Change No. 14  
License Nos. DPR-32  
and DPR-37

CHANGE NO. 14 TO THE TECHNICAL SPECIFICATIONS

OPERATING LICENSES NOS. DPR-32 AND DPR-37

DOCKET NOS. 50-280 AND 50-281

FIGURE 6.1-1

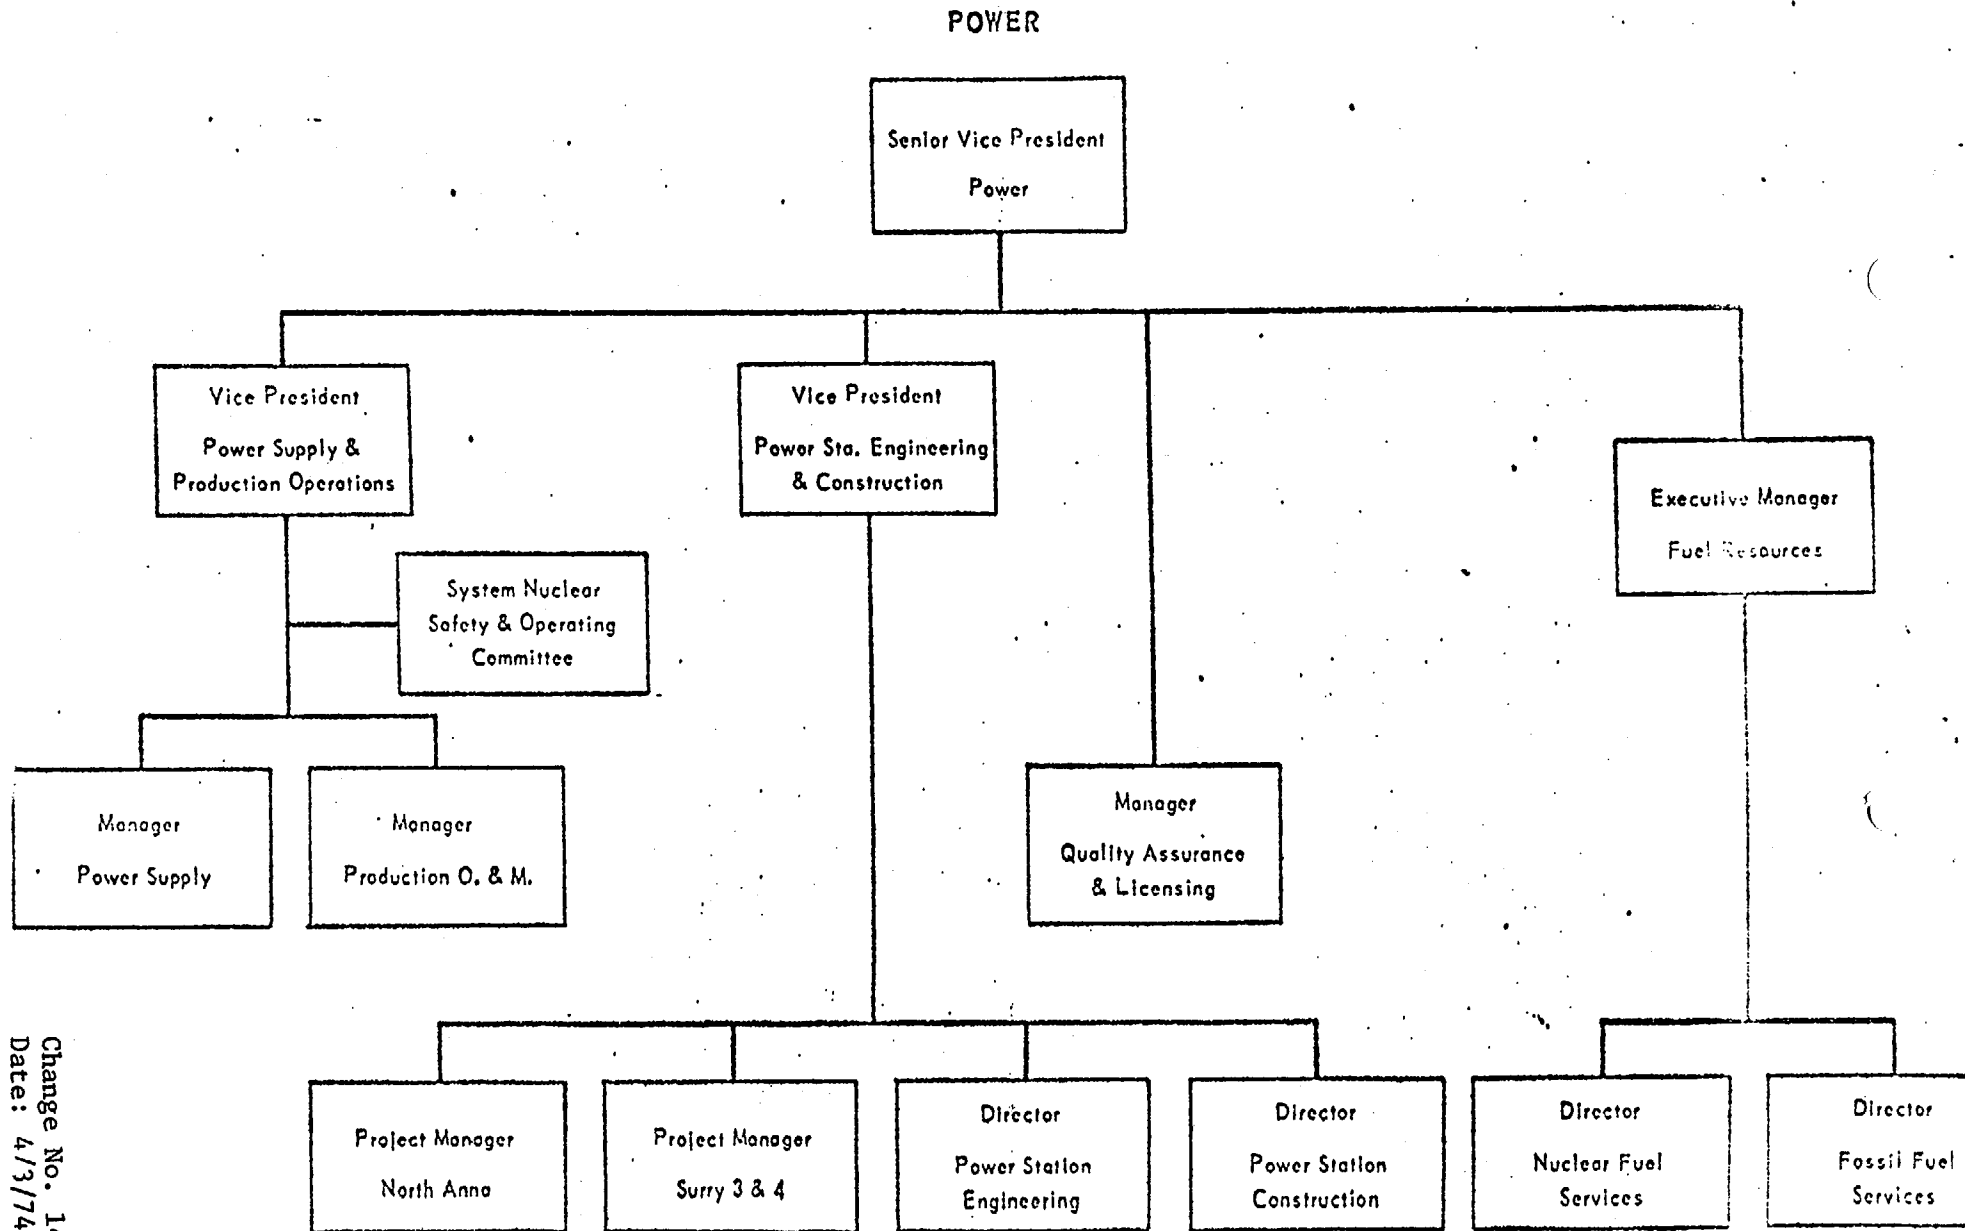
4. Replace Figure 6.1-1 with the attached figure.

The proposed changes to Section 6.1-1 reflect organizational changes that went into effect within VEPCO on January 1, 1974, and are found acceptable.
